10 July 2019

Re: Austen Quarry – Request for Information regarding Modification 2 to Development Consent SSD 6084

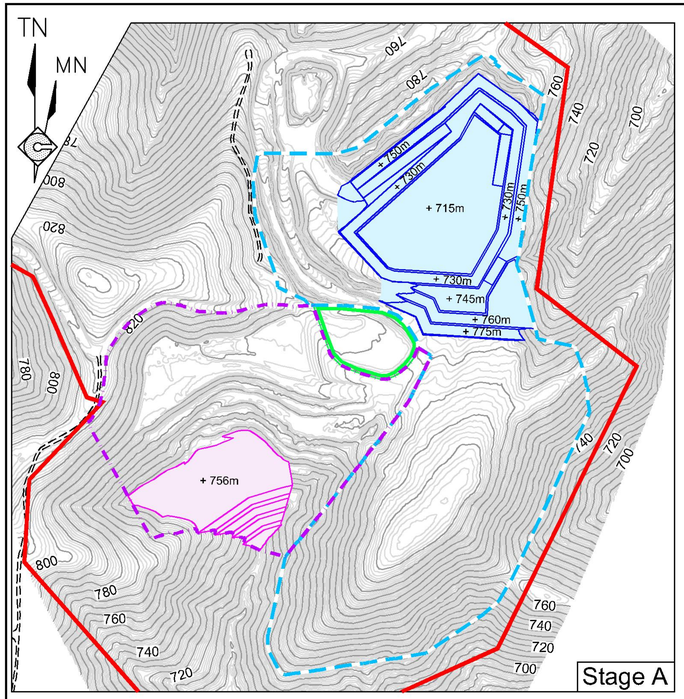
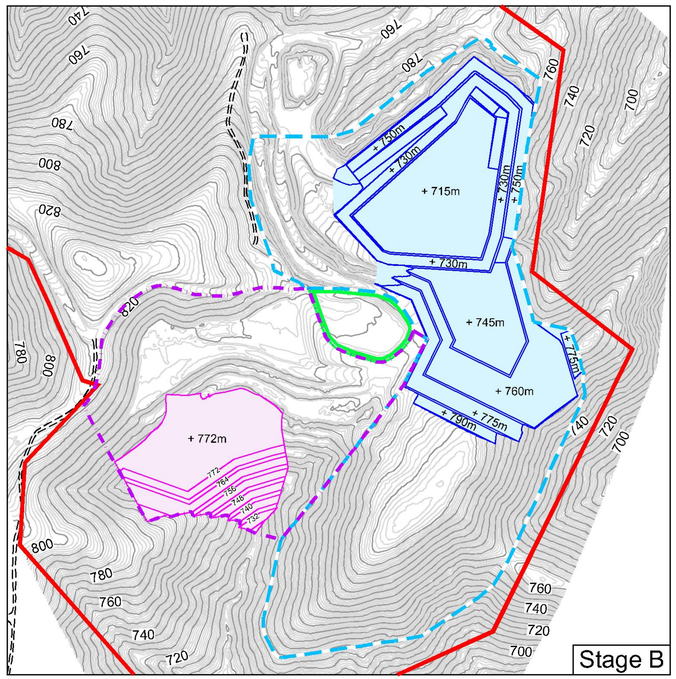
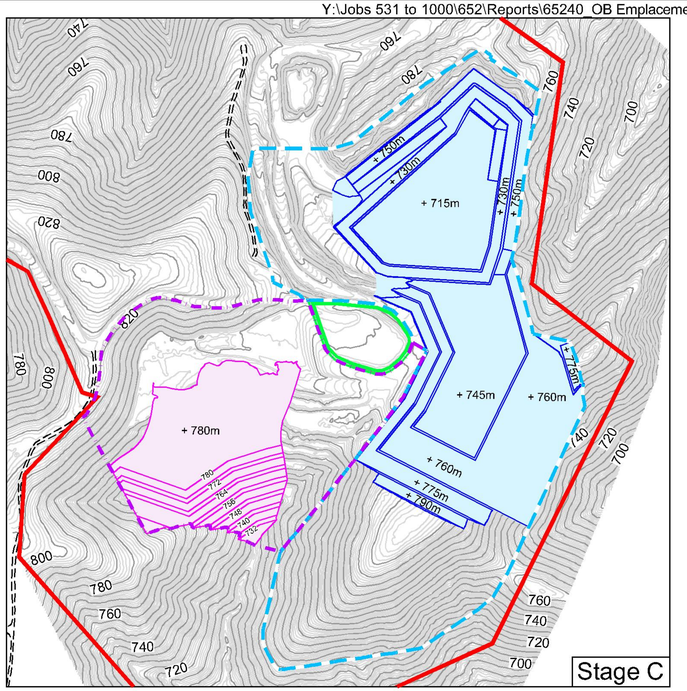
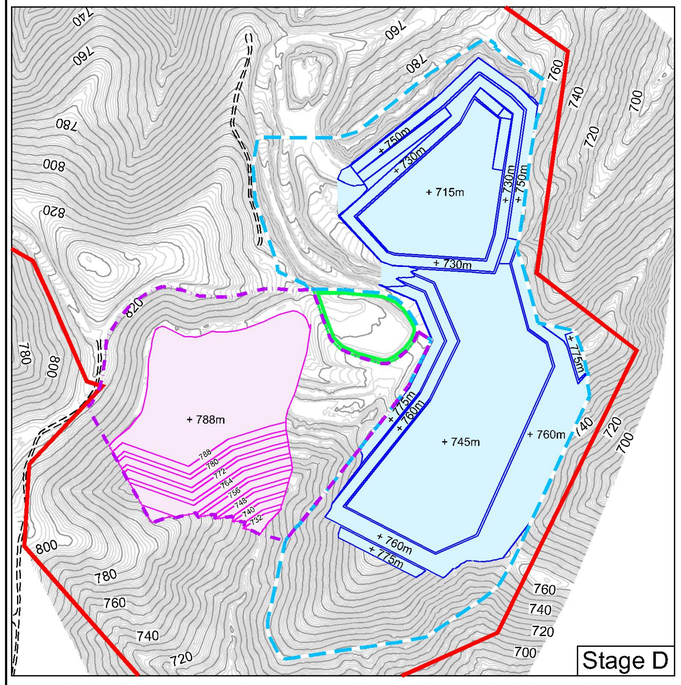
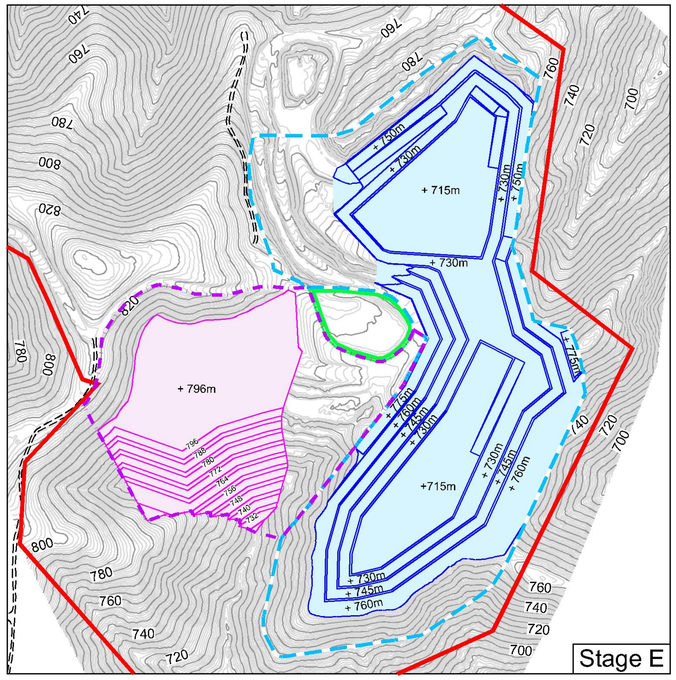
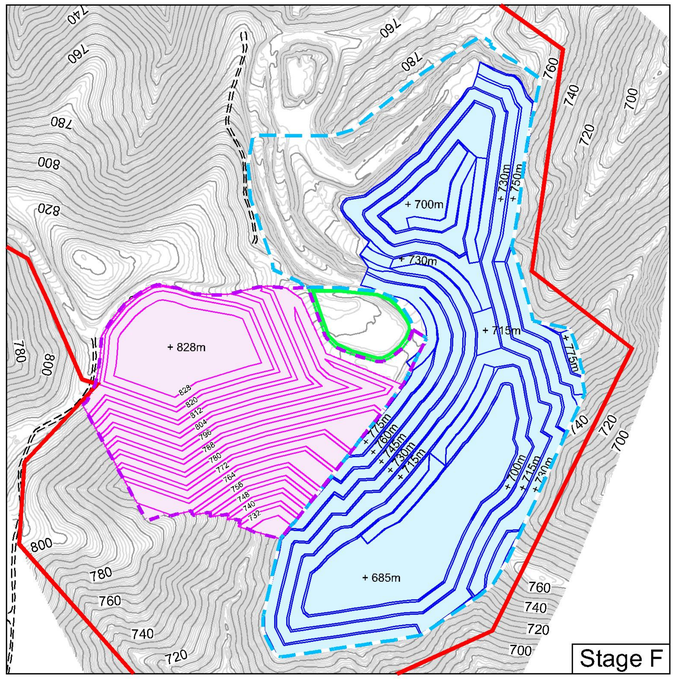
I note that the Indicative Sequence of Extraction and Overburden Emplacement figure is currently referenced in Statement of Commitments 6.1(a) as being located in the Statement of Environmental Effects for the Modification 1 application. As we have previously discussed, we propose that this reference be modified to refer to the figure presented in the Landscape and Rehabilitation Management Plan. My rationale for this modification is as follows.

1. The sequence and design presented in this figure is indicative. As you would be aware, quarry development is strongly influenced by localised geology. This determines safe and stable face and bench development as the extraction area is progressively developed. Therefore, it is not appropriate for the specific design of these stages to be specified in any development consent.
2. Given the focus on development compliance, we wish to avoid a situation where an auditor is requesting a comparison of face heights, bench lengths and orientation in order to assess compliance.

3. The ultimate limits to the extraction area and overburden emplacement design are the boundaries presented in the site layout figure and the final elevations of each site component.

5. It is appropriate to include a schedule of extraction and overburden emplacement in the Landscape and Rehabilitation Management Plan where Hy-Tec describe the management and mitigation measures relating to visual amenity.

6. If the sequence is included in the Landscape and Rehabilitation Management Plan, minor changes to the design may be approved through the Department's review of that plan rather than requiring modifications to development consent. Any significant changes that DPIE consider would require assessment, would still be undertaken through a modification application. However, significant changes that would influence visual amenity are unlikely given what is known of the extraction area from Hy-Tec's many years of experience at the Quarry.
